CITY OF SAN BRUNO **COMMUNITY DEVELOPMENT DEPARTMENT**

ARCHITECTURAL REVIEW COMMITTEE
STAFF REPORT
AGENDA ITEM NO. 1.B.
November 10, 2016

Project Address: 111 San Bruno Ave. and 761 – 767 Huntington Ave.
Assessor's Parcel No: 020-276-290, 020-293-040
Application No.: PRE-16-003
Zoning District: C (General Commercial)
General Plan Classification: Transit Oriented Development
Transit Corridors Plan: San Bruno Avenue Character Area
Prepared by: Michael Smith, 650-616-7062

RE: 111 San Bruno Avenue

View of immediately adjacent multifamily residences from Huntington Avenue

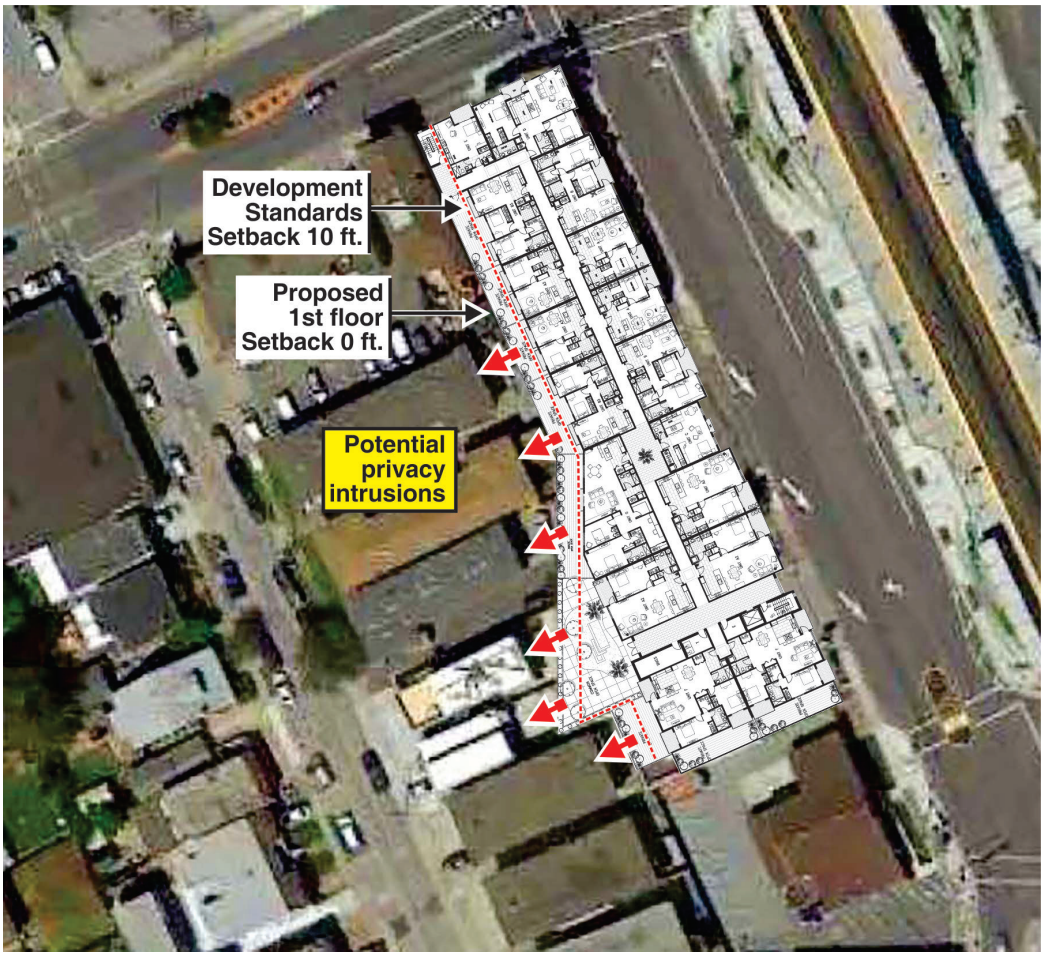
1. As noted on the applicant's drawings, the setback along the west property line is 10 feet while the drawings and table reflect a zero setback. This would present two issues relative to the immediately adjacent multifamily residential units:
   - There is a strong potential for privacy intrusions on those residences and their private outdoor spaces from residents of this project utilizing the second floor decks.
   - The approximately 20 foot high concrete wall on the property line would create a harsh new edge clearly visible from adjacent residential windows and outdoor private yard spaces.

Recommendations:

1. Add lattices with climbing vines to soften the appearance of the concrete wall.
2. Utilize concrete form inserts to add texture to the tall wall facing the adjacent residences.
3. Enhance the deck edge landscaping to minimize privacy intrusions.

Elevator is not well located to serve the common open space

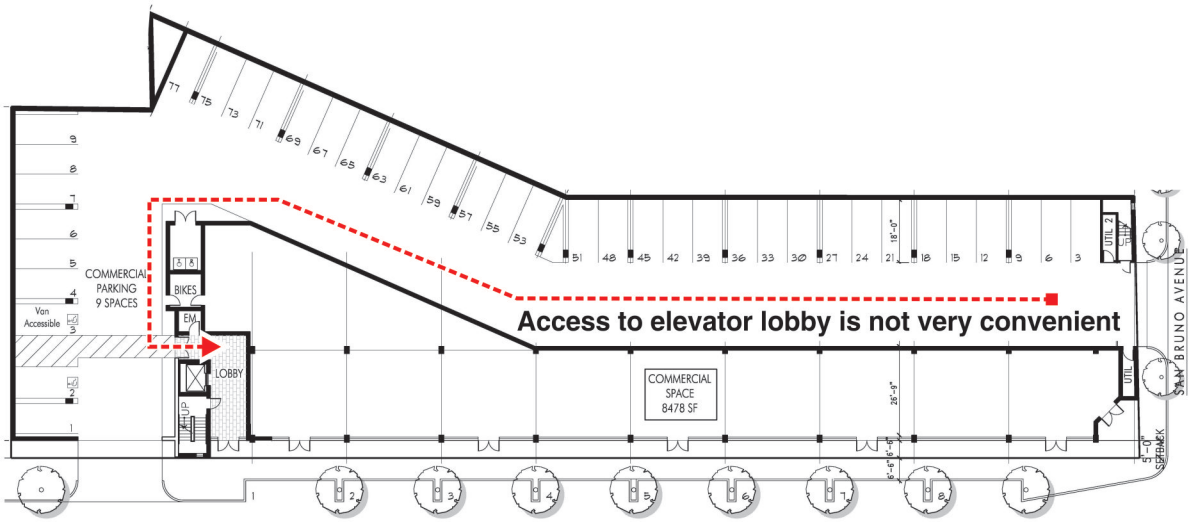
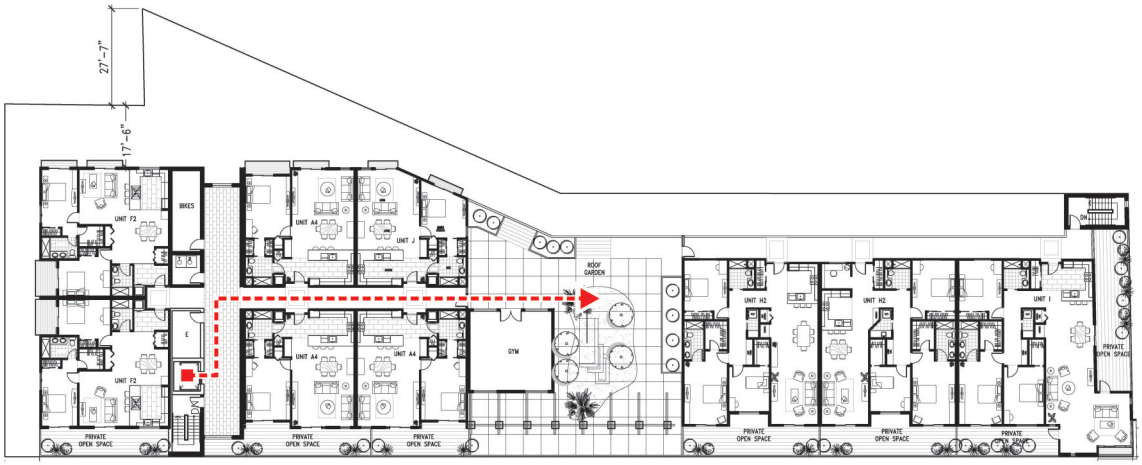
2. The project's elevator and stair lobby is not very well located for access from the residential garage and for access by the residents to the Common Roof Garden on the fifth floor.

Recommendation:

1. Consider relocating the elevator and stair to a more central location.

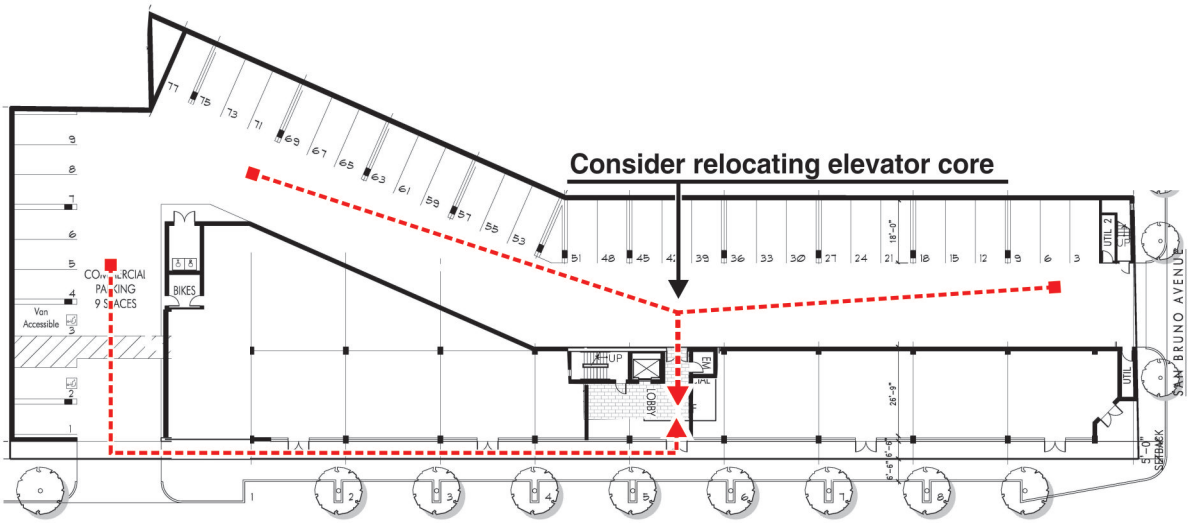
3. A couple of minor clarification items.
   - The San Bruno Avenue sketch and the floor plans do not match regarding the western most balconies. The sketch shown small faux balconies while the floor plans show deeper inset balconies as shown to the left in the sketch.
   - Since the garage gate is very prominent on both the San Bruno Avenue and Huntington Avenue elevations, requesting a photo showing the proposed material and pattern would be desirable.
